Access Compliance Report

Public Rights-of-Way

Intersection ID: 29422	Main Street: BRADSTREET_COMMONS_WY	Cross Street: SHINY_MEADOW_LN	Location: NW
ADA ID: 03E796AA5C22	Ramp Type: Perp	Initial Pass/Fail: Fail	Overall Compliance: No
		Severity Score: 25

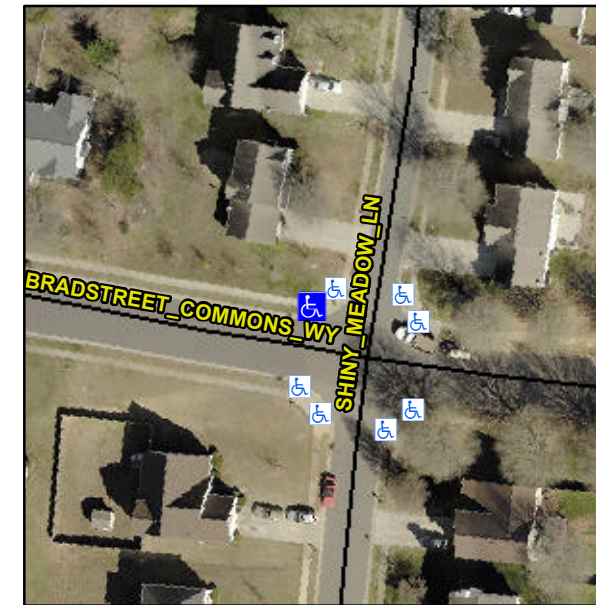
R304.5.3

Remove & Replace Entire Ramp.
